Re: S/D 97-70 One-Step Final Plat Of ECK 5TH ADDITION

At the regular meeting of the Subdivision Committee of the Metropolitan Area Planning Commission on Thursday, September 18, 1997, the above captioned plat was considered. The action of the Committee was to approve the plat, subject to the following:

CASE NUMBER: S/D 97-70 ECK 5TH ADDITION

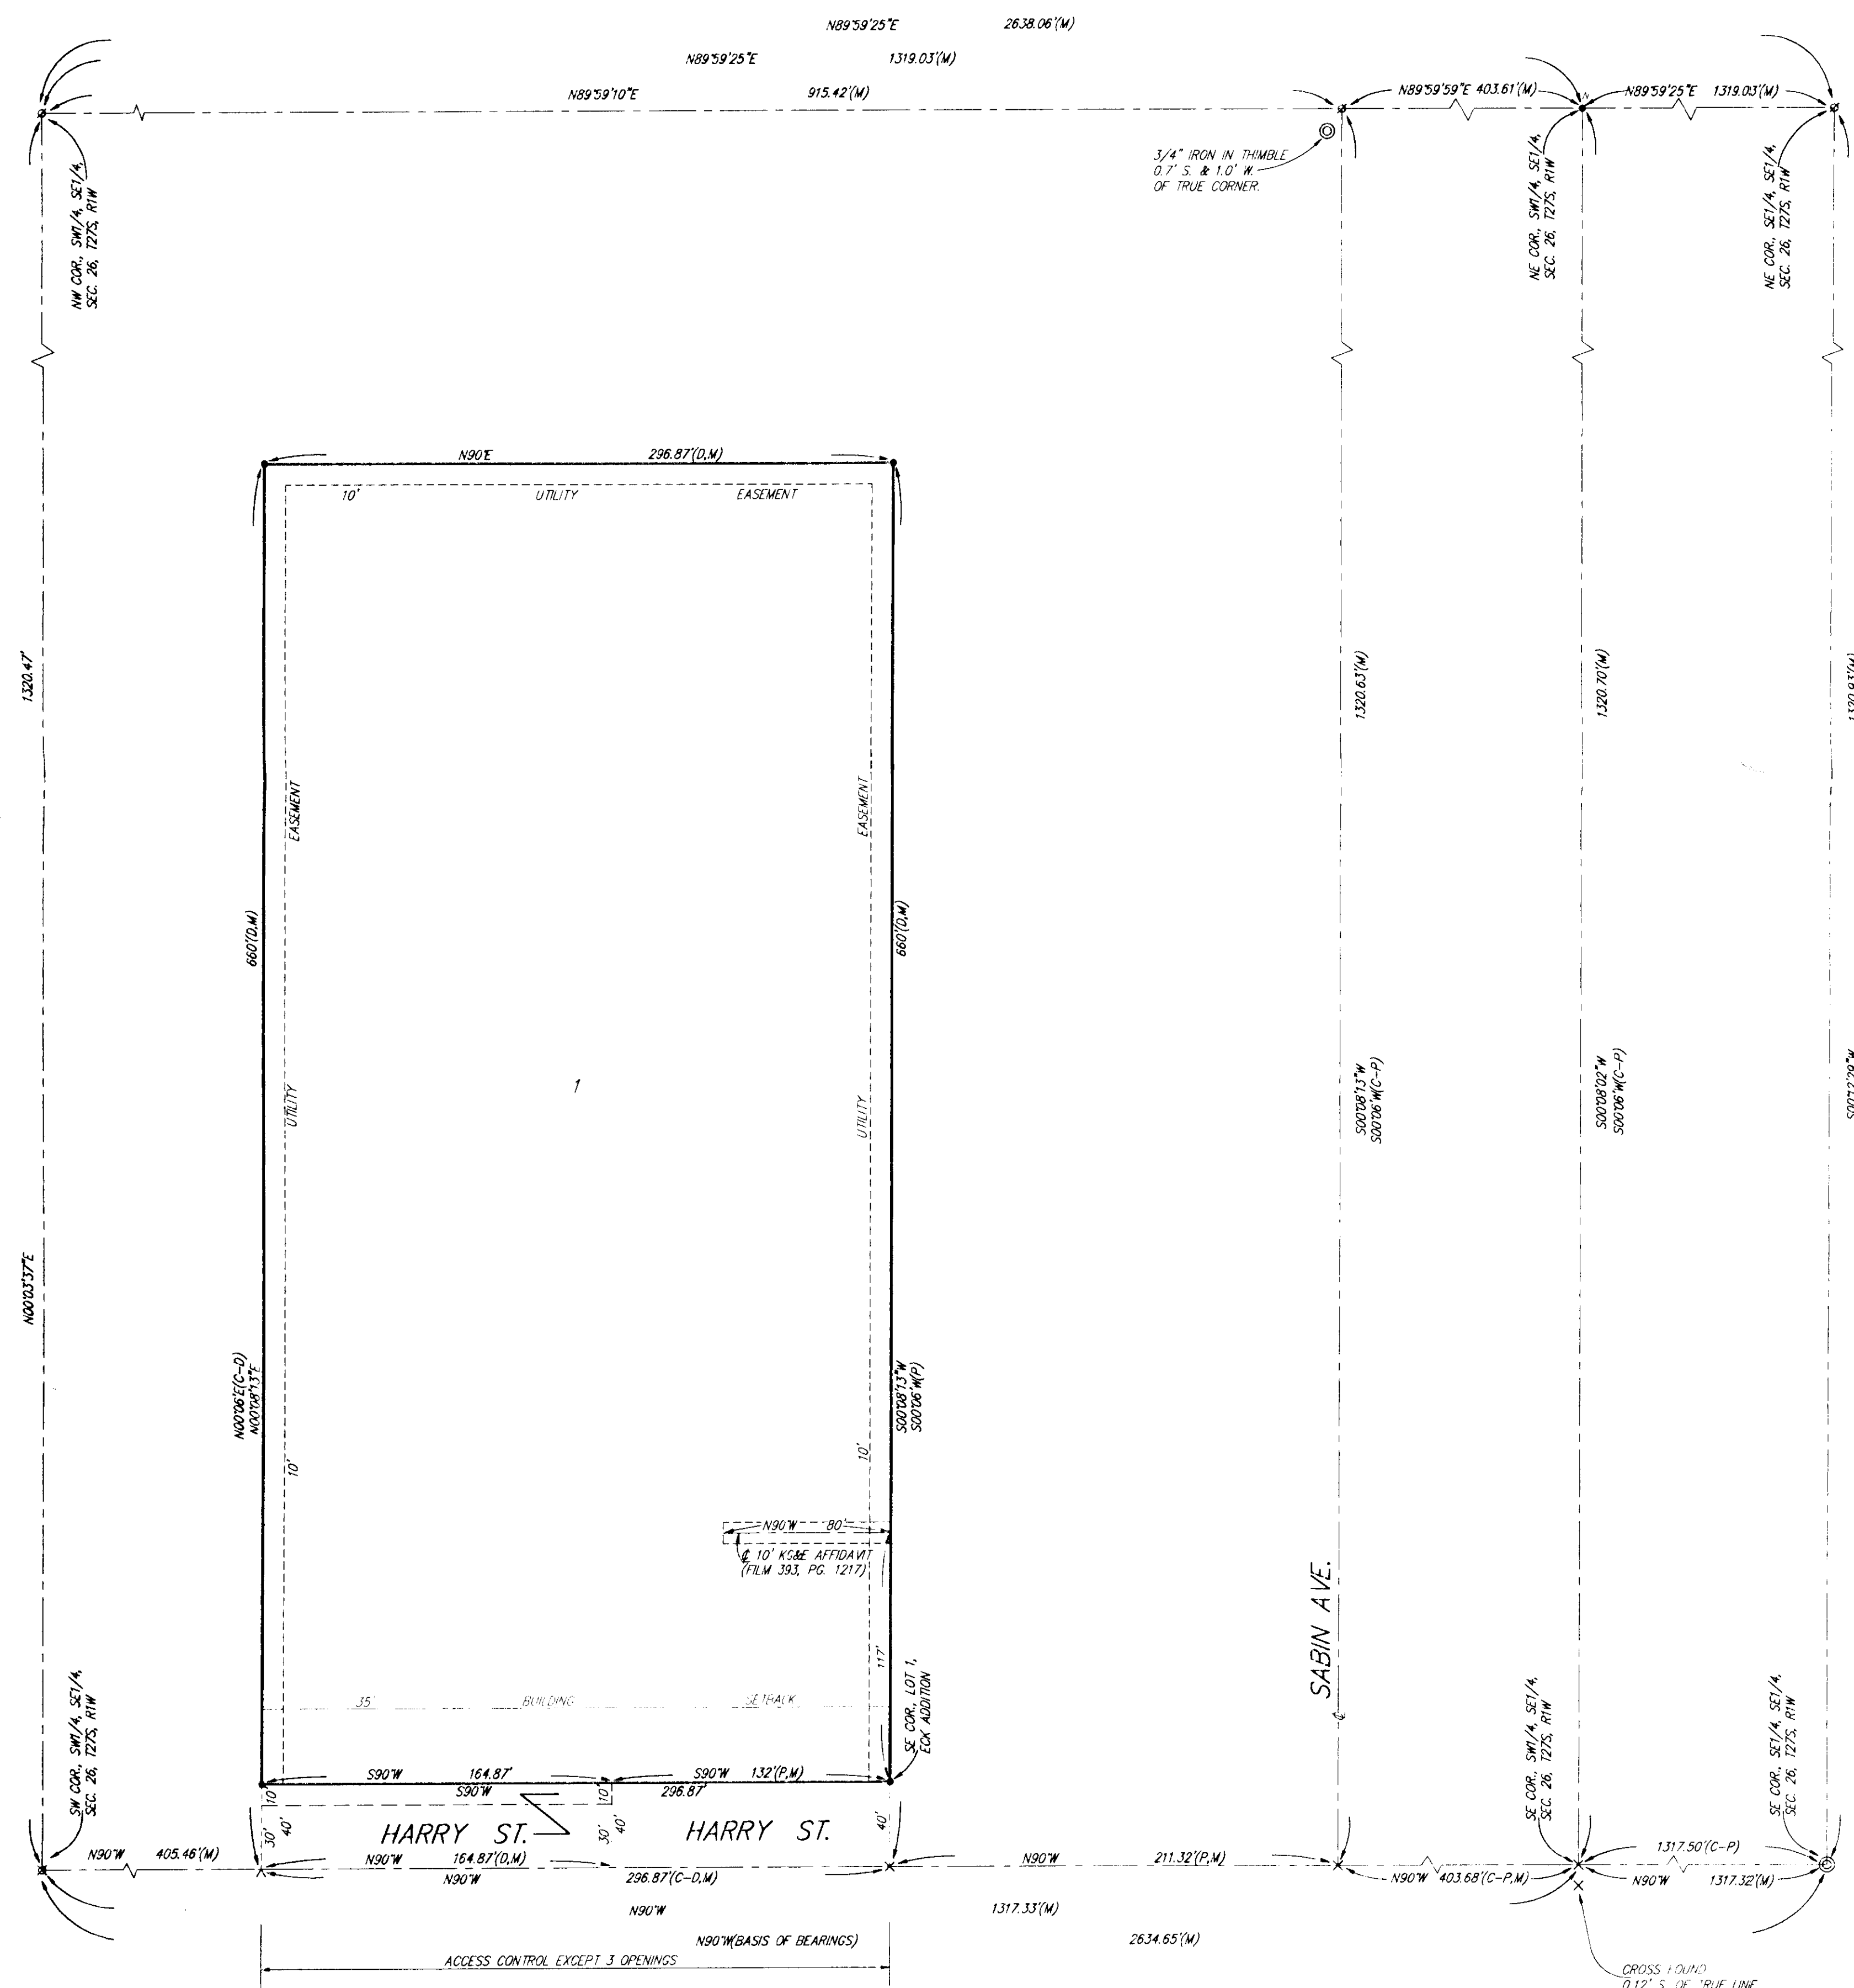
- M. The scale should be corrected on the final tracing. The preliminary plat has a scale of 1 inch equals 50 feet and the final plat has a scale of 1 inch equals 100 feet. Both drawings are the same size but have different scales are shown on the plat.

- N. The distances from the tie point to the point of beginning do not correlate with those in the plat's text. Before the final tracing is submitted this should be corrected.
